**Conceptual Site Plan**  
**Detailed Site Plan**

**CSP-18009**  
**DSP-18032**

Application	General Data	
<b>Project Name:</b> Landover Crossing Shopping Center  <b>Location:</b> In the southeast quadrant of the intersection of MD 202 (Landover Road) and Brightseat Road.  <b>Applicant/Address:</b> Landover (Landover Crossing), LLC 8816 Six Forks Road, Suite 201 Raleigh, NC 27615	Planning Board Hearing Date:	03/28/19
	Staff Report Date:	03/12/19
	Date Accepted:	01/28/19
	Planning Board Action Limit:	04/08/19
	Plan Acreage:	19.61
	Zone:	M-X-T
	Dwelling Units:	N/A
	Gross Floor Area:	177,125 sq. ft
	Planning Area:	72
	Council District:	05
	Election District:	13
	Municipality:	N/A
	200-Scale Base Map:	203NE08

SUBJECT: Conceptual Site Plan CSP-18009  
Detailed Site Plan DSP-18032  
Landover Crossing Shopping Center

# OVERALL DETAILED SITE PLAN

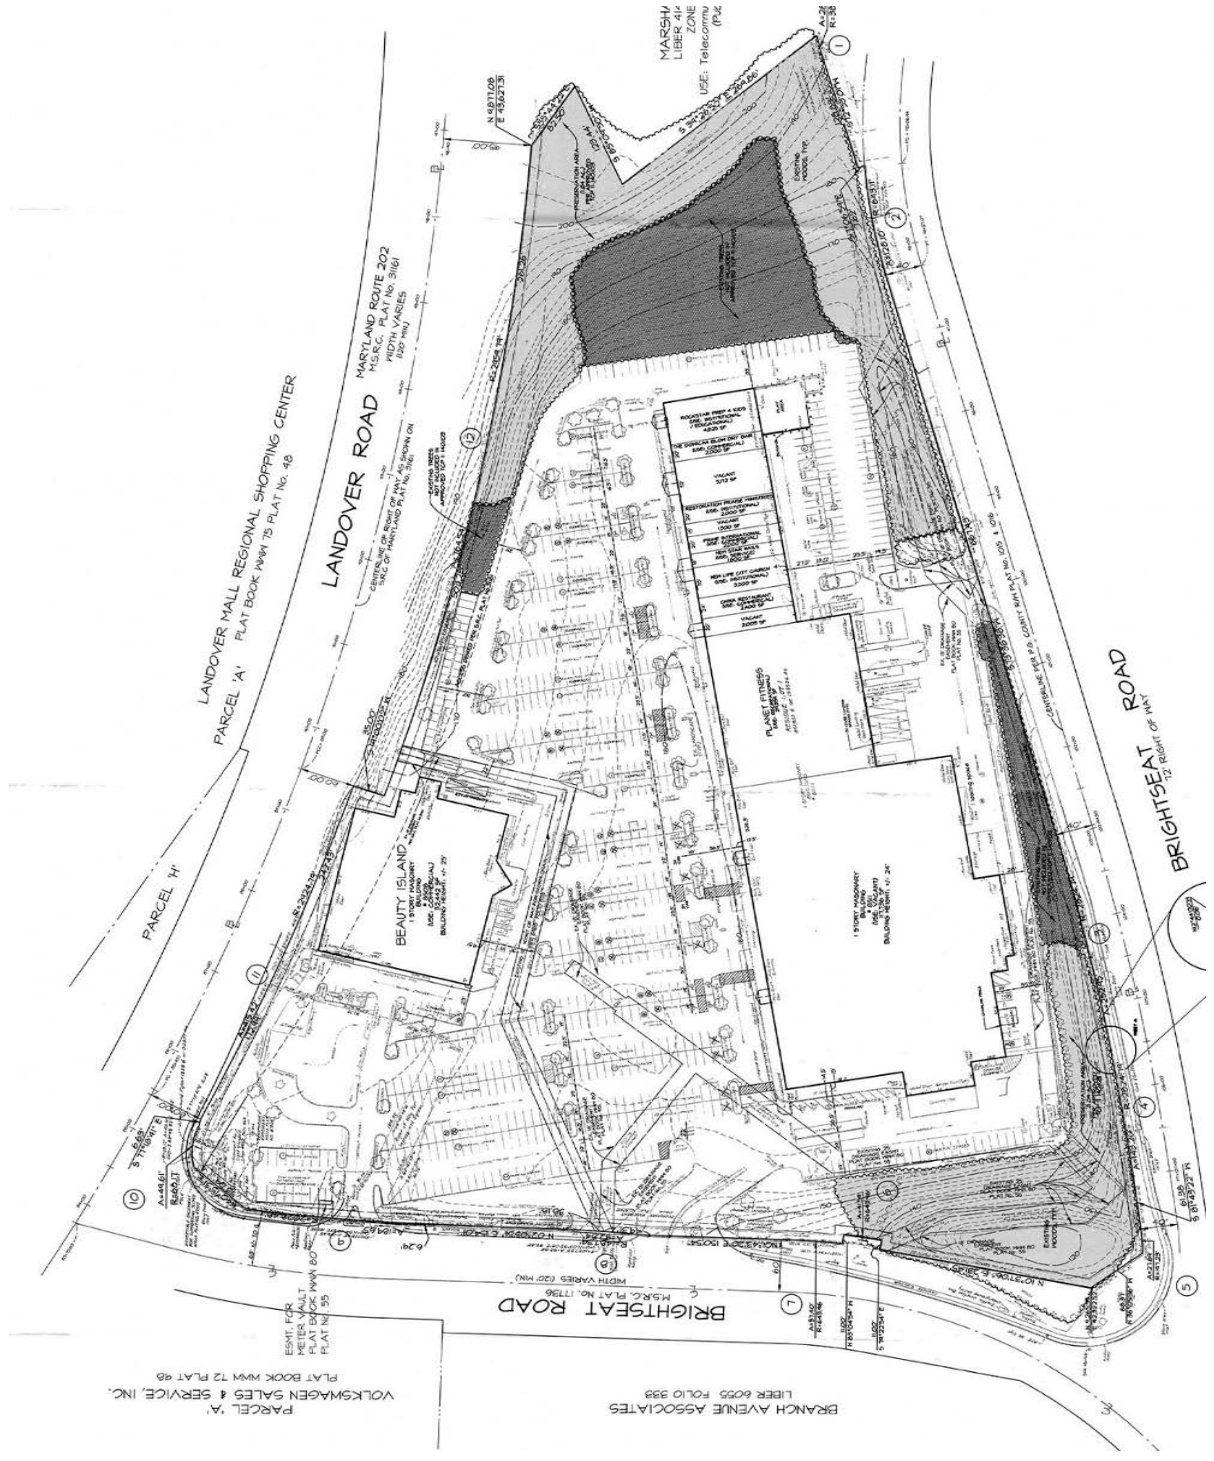
**Notes:** \*The total square footage is shown incorrectly on the plan as 206,537 and the applicant indicated the correct number for the overall integrated shopping center is 177,125, consistent with the prior use and occupancy permit. Therefore, a condition has been included in the Recommendation section of this report to provide the correct GFA of the overall integrated shopping center in the general notes and on the plan where appropriate. In addition, it is noted that the plan does not provide a schedule showing a breakdown of the tenant spaces and uses and their square footages which should be provided for future permitting. Therefore, a condition has been included in the Recommendation section of this report to provide a schedule of tenant uses with their square footage.

\*\*\*\*The DSP shows 728 parking spaces and 7 loading spaces; however, a parking and loading schedule has not been provided showing the type and number of spaces proposed. A condition has been added to the Recommendation section of this report requiring the applicant to revise the DSP to provide a parking and loading schedule to show the type and number of parking spaces proposed.

The FAR information is not shown and should be added to the general notes on the CSP/DSP, as conditioned herein. The FAR of the existing buildings are 0.20 based on the GFA of 177,125 square feet. However, as stated previously, this should be confirmed and should exclude basement storage areas and mechanical element areas. The existing buildings are legal, and were developed prior to the property being zoned M-X-T.

- (2) In accordance with Section 27-274(a)(2)(B), loading areas should be visually unobtrusive, and loading should also be located to the side or rear of the building and be visually screened from public roadways. Seven loading spaces are provided and are located to the rear of the buildings and in areas away from public view. However, it is noted that the plan does not provide a loading schedule. Therefore, a loading schedule should be provided to show the required and provided number of loading spaces for the integrated shopping center, as conditioned herein.

Trash facilities appear to be shown on the southern and western sides of the site and are appropriately screened. However, these are not clearly labeled on the plan. Therefore, a condition has been included in the Recommendation section of this report requiring the applicant to clearly label these locations on the plan, and screen or enclose them with an evergreen screen, or sight-tight fence, that is compatible with the building.

- a. Provide the existing floor area ratio information in the general notes on the DSP.
    - b. Provide the correct square footage of the integrated shopping center on the DSP where appropriate.

- c. Provide a parking and loading schedule to show the type and number of required and proposed parking and loading spaces, in accordance with Sections 27-574 and 27-583 of the Prince George's County Zoning Ordinance.

- d. Provide a schedule of tenant spaces and uses including their square footage, which should exclude those portions of the basement that are used exclusively for storage or other areas used exclusively for mechanical elements.

- g. Provide the plan's applicable record plat reference, NLP 145-90, in the general notes.
